Service Bulletin #200

December 3, 1965

BATTERIES AND FUSE IN 1966 A65 LIGHTNING, THUNDERBOLT AND ROYAL STAR 500 MODELS: MUST BE INSPECTED & SERVICED AS FOLLOWS:

1966 A50 and A65 Models.

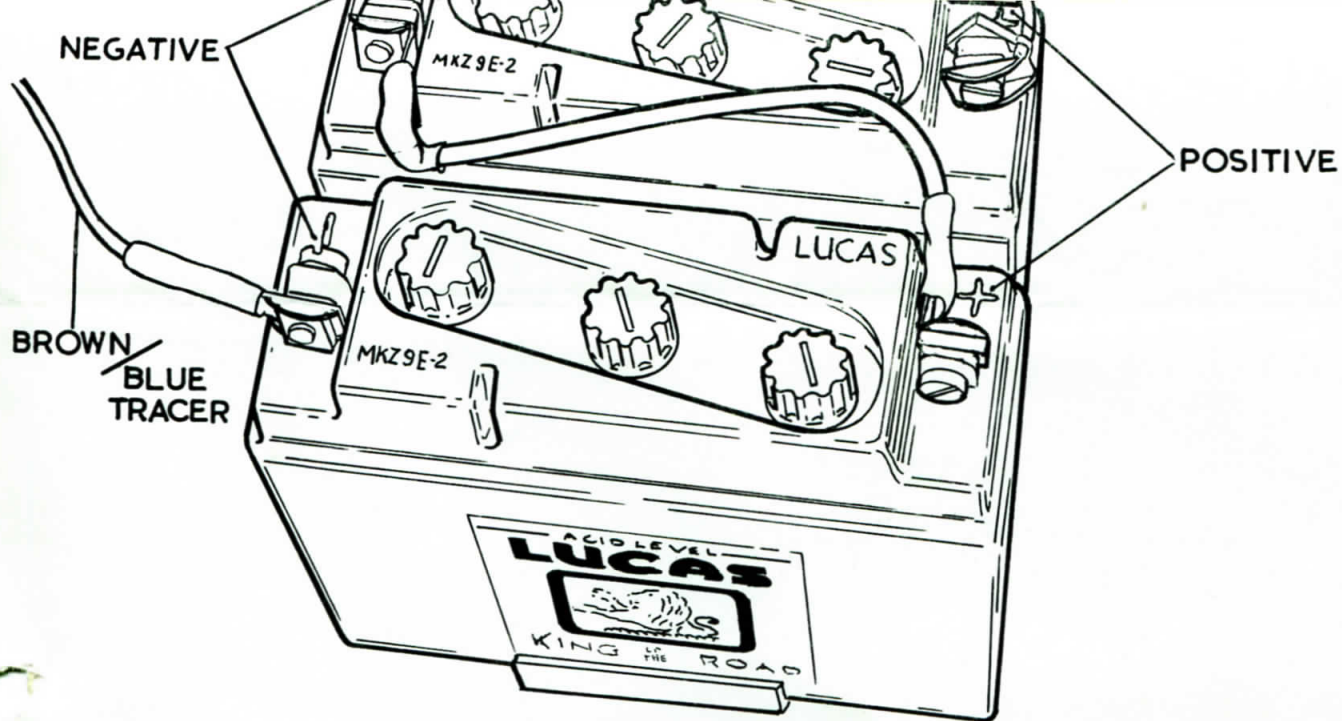
The first deliveries of 1966 battery ignition models are fitted with fuses in the red earth (ground) wire from the positive battery terminal. Experience has shown that failure of this fuse can lead to mechanical trouble should the engine continue to run while the battery is in open circuit.

To safeguard against this problem, the red fused lead must be replaced by a ground wire without a fuse before machines are sold.

In addition to this replacement it is important to note that a few machines have left the factory with the uncharged batteries fitted to the machine the wrong way round. Dealers must note the correct position of each

In addition to this replacement it is important to note that a few machines have left the factory with the uncharged batteries fitted to the machine the wrong way round. Dealers must note the correct position of each battery and the wires connecting the batteries as shown in the above illustration and should not simply replace the battery pack in its original position following filling and initial charge.

Caution: Be sure the battery connecting wires are in place and do not touch or rub against the battery carrier bracket.
